**Cambridge Cycling Campaign**

**Station Area Redevelopment – CB1  
Planning Application Reference: 06/0008/OUT**

This letter is to lodge an objection by Cambridge Cycling Campaign to the above planning application on matters relating to cycling and transport.

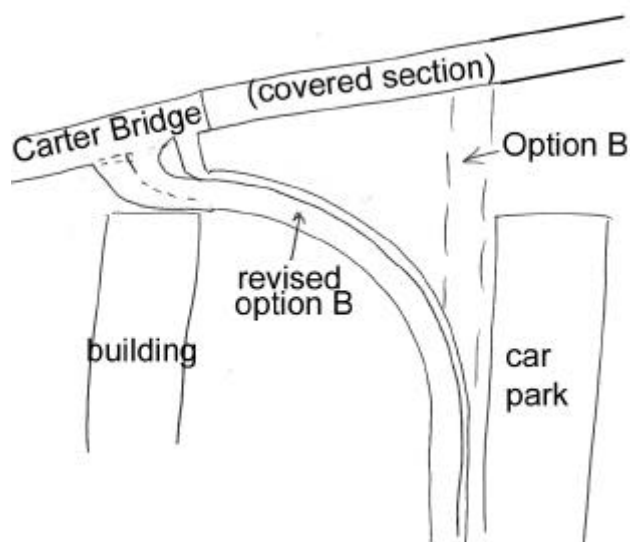
We **object** to ramp option A (looping under the bridge starting on the north side). It is an inadequate solution offered primarily to avoid impinging on the development rather than its main purpose, namely to improve access to the station for cycles. This option also introduces unnecessary crossing movements on the bridge and mixes cyclists and vehicles at the car park entrances.

While we welcome option B (a straight ramp), we are advised by a structural engineer that it is unlikely to be structurally practical as proposed. We think it would not be difficult to join such a ramp at a point opposite the point proposed for option A, and that this should be

provided for as a planning condition if option B as proposed is not workable (see Figure). Whatever the joining point, visibility needs to be considered in *both* directions at the junction with the bridge, so sufficient space must be allowed at the joining point for a large platform.

- 2.4. There must be a ramp with a gradient no greater than 5% leading from the south side of the Carter Bridge directly into the station area suitable for use by cyclists and pedestrians.
- 2.5. The ramp from Carter Bridge must pass over or under the car park entrances.
- 2.6. The ramp must be constructed to at least the same standard (total width, allocation between cyclists and pedestrians, and separation method) as the existing bridge.
